U.S. Department  
of Transportation  
**Federal Highway  
Administration**

Refer to: HSA-10/WZ-108

Thank you for your letter of January 9, 2002, requesting Federal Highway Administration (FHWA) acceptance of your company's portable sign stands and barricades as crashworthy traffic control devices for use in work zones on the National Highway System (NHS). Accompanying your letter was a report of the crash testing conducted by Karco Engineering and a video of the tests. You also asked for our review of the results of tests 1, 2, 3, and 5 that accompanied your July 9, 2001, letter (as you requested at the time we limited our review to the Little Buster stand, the subject of test 4.) You requested that we find these devices acceptable for use on the NHS under the provisions of National Cooperative Highway Research Program (NCHRP) Report 350 "Recommended Procedures for the Safety Performance Evaluation of Highway Features."

Figure 1. - Rubber Pole Base with 40 lb. Ballast, Thirty-six Inch by Thirty-six Inch Aluminum Sign, and Light.

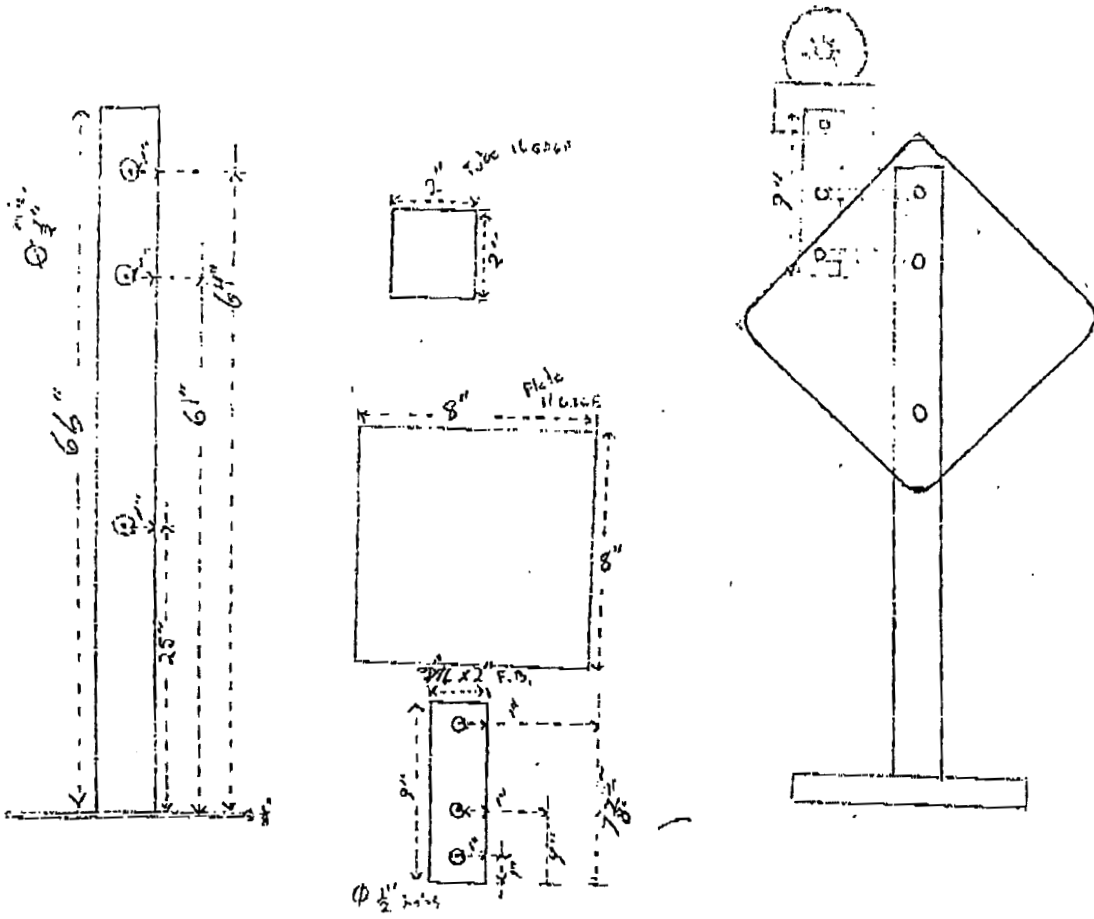
Windshield damage in Test 1 was primarily due to the flat impact of the warning light. A small but dense area of cracking was surrounded by more moderated spider web cracking. A driver should be able to see around the opaque area.

Test 1. **Sign Stand. Rubber Pole Base with 30 pound ballast, 36 x 36 inch aluminum sign, and light.** Acceptable, but marginal

Figure 2. – Big Buster Sign Stand with Forty-eight Inch by Forty Eight Inch Aluminum Sign, Aluminum Inner Mast, and Plastic Flag Holder; Sign Height Sixty-six Inches Above Ground.

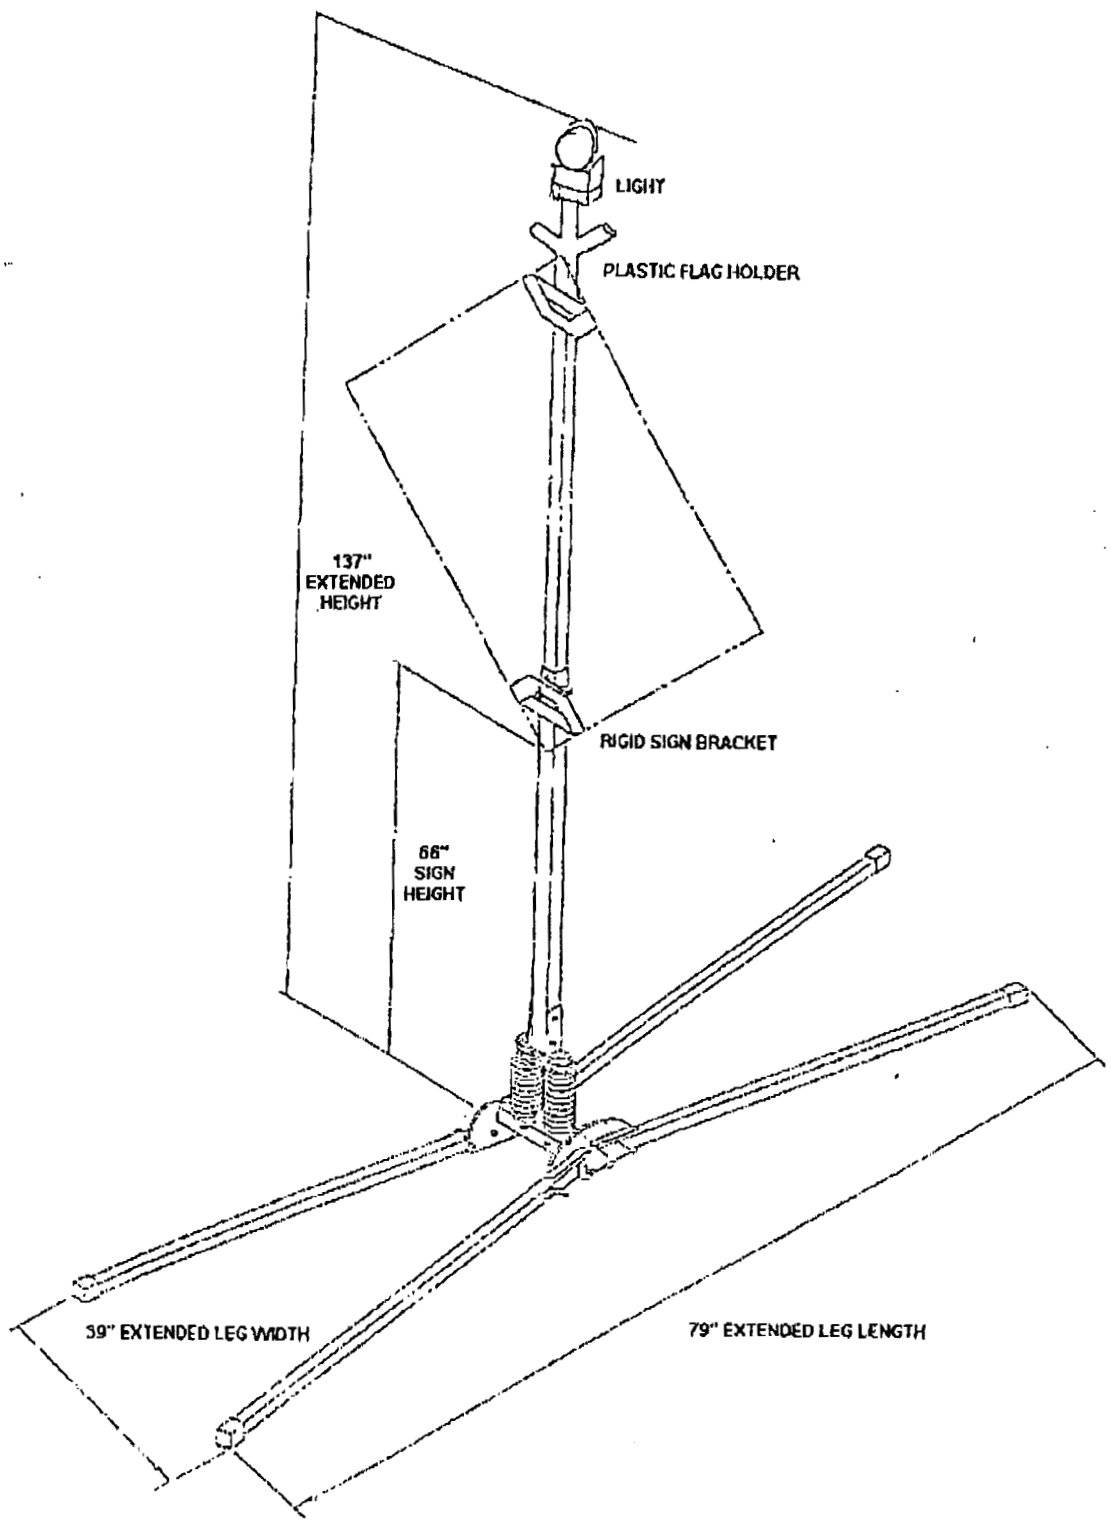
Windshield damage in Test 2 was due to the impact of the sign's mast contacting the roof line. Moderate cracking radiated from this impact point.

Test 2. **Big Buster Sign Stand with 48 x 48 inch aluminum sign.** Acceptable

Figure 1. – Little Buster Sign Stand with Forty-eight Inch by Forty-eight Inch Aluminum Sign with Slip-over Tube Mast; Sign Height Eighteen Inches Above Ground.

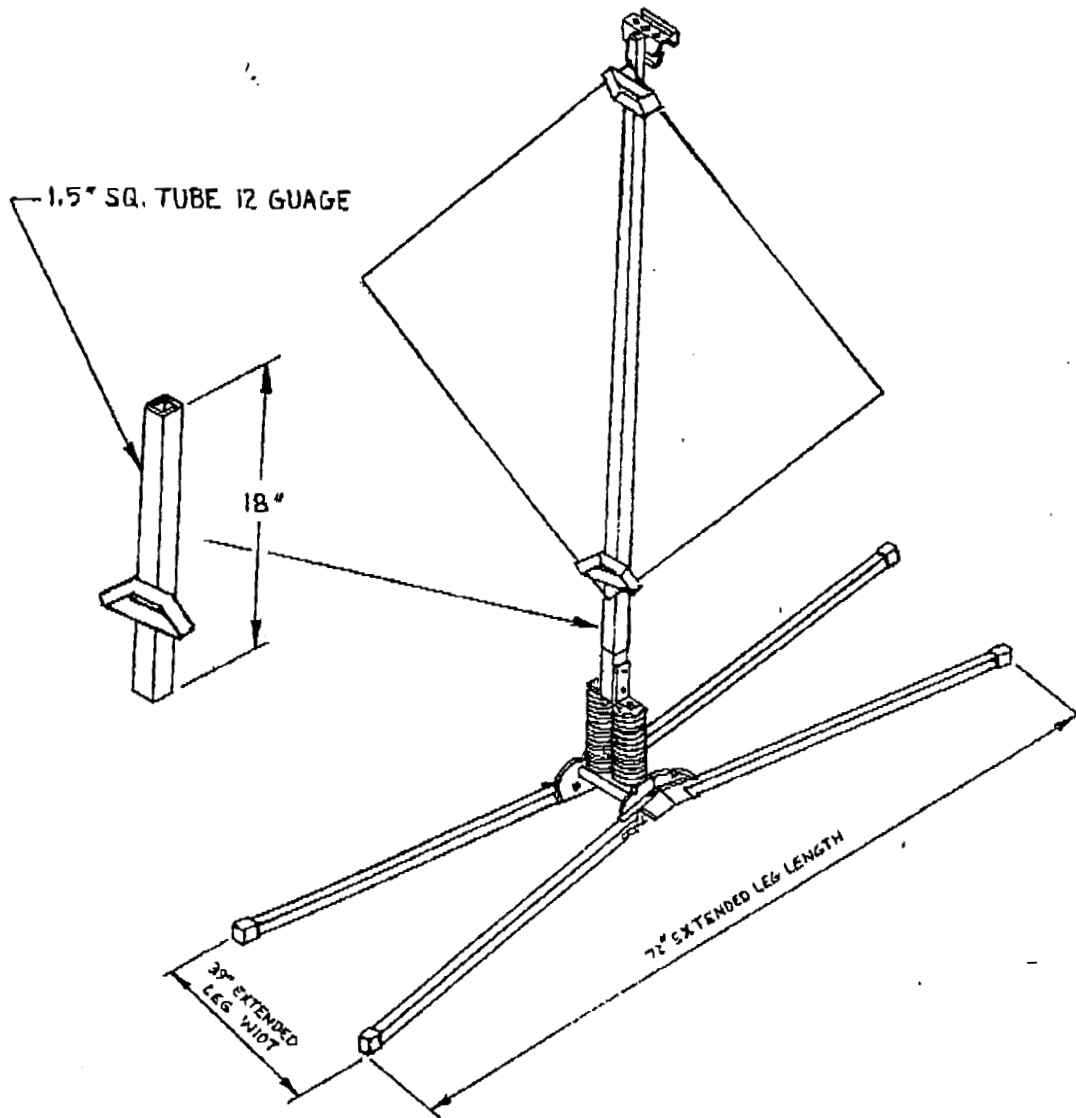
Windshield damage in Tests 1 and 3 resulted from the flat impact of the aluminum sign panel in the head-on test. Cracking was distributed over the whole windshields of both cars but did not significantly impair the driver's ability to see. Deflection of the glass was between two and three inches. Therefore, this device will be considered marginally acceptable.

Test 1. **Little Buster Sign Stand with 48 x 48 inch aluminum sign with Slip-over Tube Mast.** Acceptable, but marginal

Figure 2. - Type 3 Plastic Barricade with Plastic Posts and Pinned Rubber Bases, Forty-eight Inch by Forty-eight Inch Corrugated Plastic Sign; Sign Height Twelve Inches Above Ground.

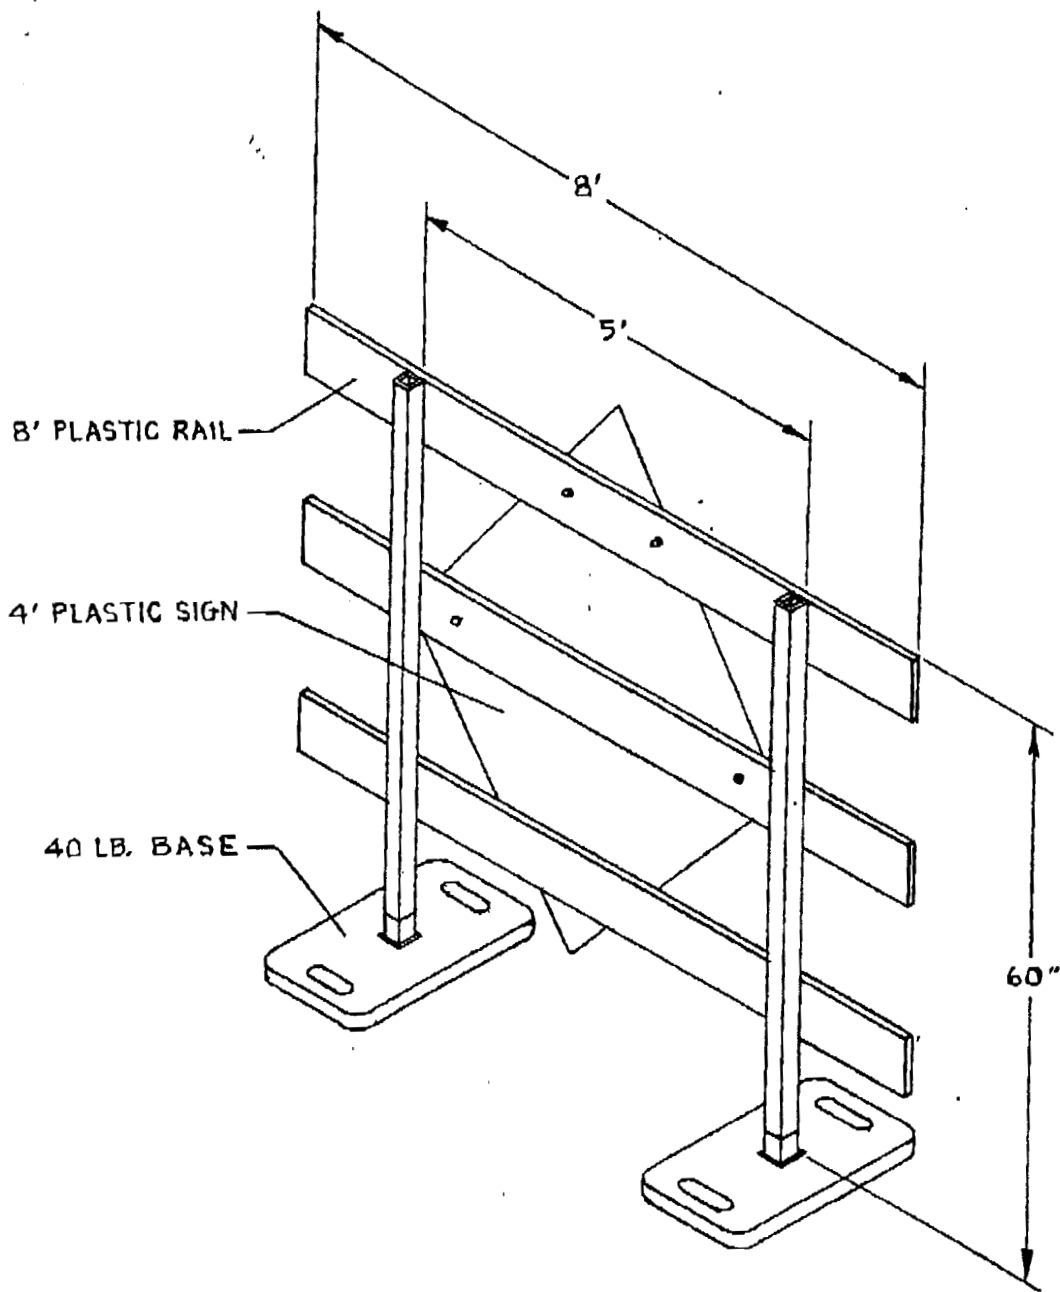
Test 2 was of a plastic framed Type III barricade. The vertical supports of this barricade shattered upon impact, allowing the horizontal rails to strike the windshield in both the head on and 90 degree tests. Although there was no windshield penetration in this case, the potential for rigid horizontal panels to spear the vehicle is higher. It is critical, therefore, that this design use flexible, lightweight horizontal rails as tested. The corrugated plastic sign panel mounted on the barricade is acceptable for use as tested.

Test 2. **Type III Plastic Barricade with Plastic Posts and Pinned Rubber Bases, carrying a 48 x 48 inch diamond sign.** Acceptable, but marginal

Figure 4. — Type 3 Plastic Barricade with Steel Post Uprights with Lights, Forty-eight Inch by Forty-eight Inch Aluminum Sign; Sign Height Twelve Inches Above Ground.

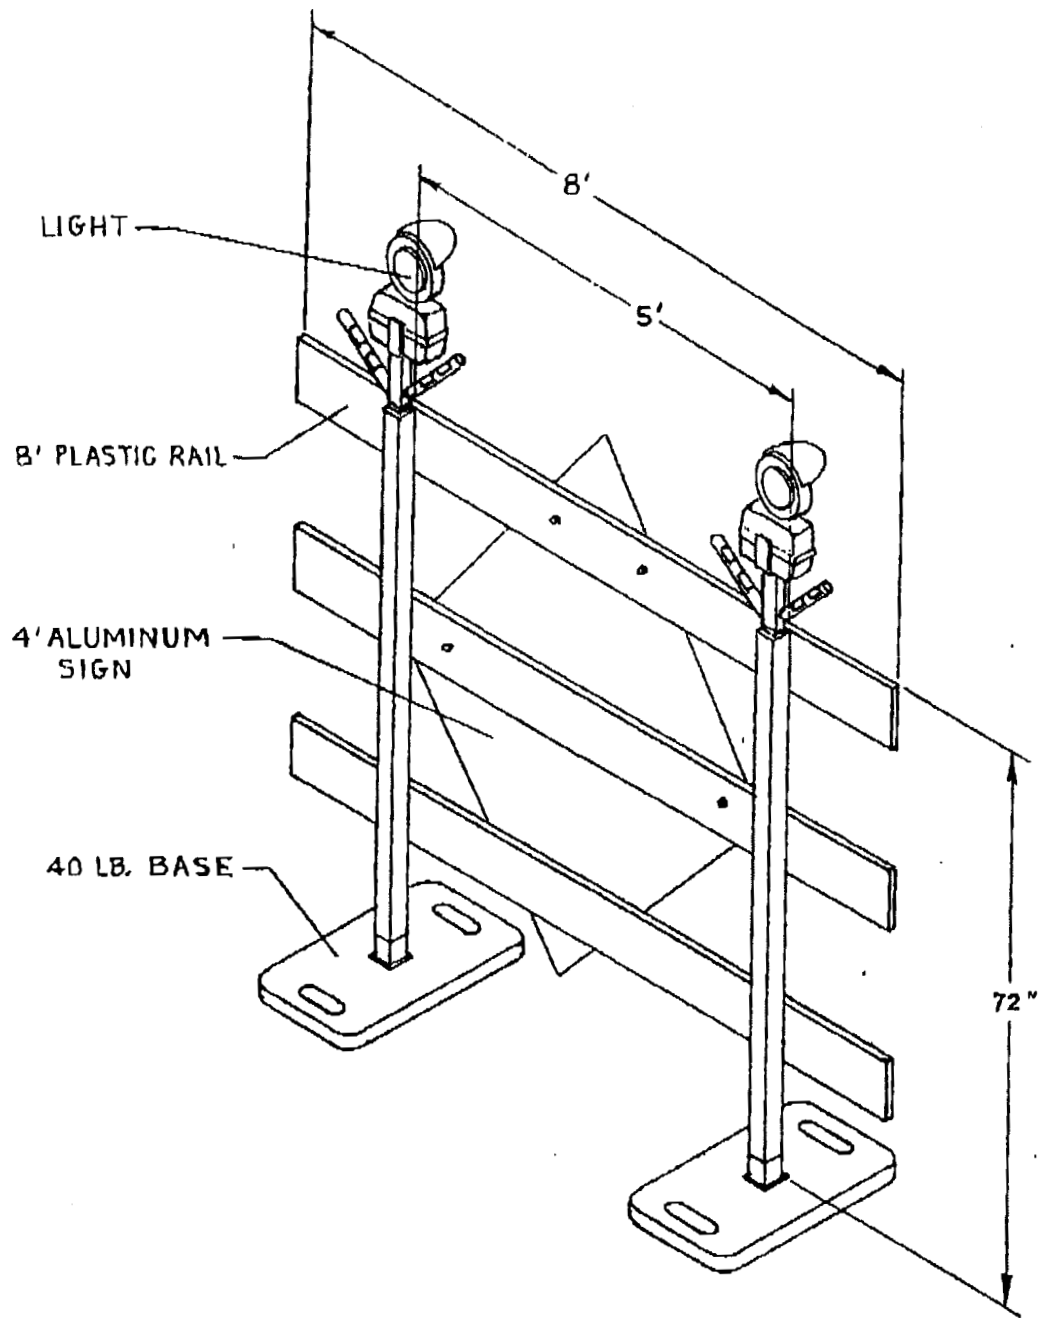
Windshield damage in Test 4 also resulted from the flat impact of the sign panel mounted to the barricade. The light gage steel vertical supports crumpled upon impact. The performance of these vertical supports was better than the plastic supports in Test 2, but did not hold the barricade together as well as the hot-rolled, high carbon steel angles, nor the perforated square steel tubes used in the generic Type III barricade designs distributed by the FHWA in our letter WZ-85. Even though the results of this test were acceptable, FHWA discourages the use of rigid aluminum or plywood sign panels centered on Type III barricades. We prefer that lightweight plastic sign substrates be used in this location, such as the sign in Test 2.

Tube 4. **Type III Plastic panel Barricade with Steel Post uprights and Lights, tested with 48 x 48 inch aluminum sign.** Acceptable with lightweight plastic sign panel
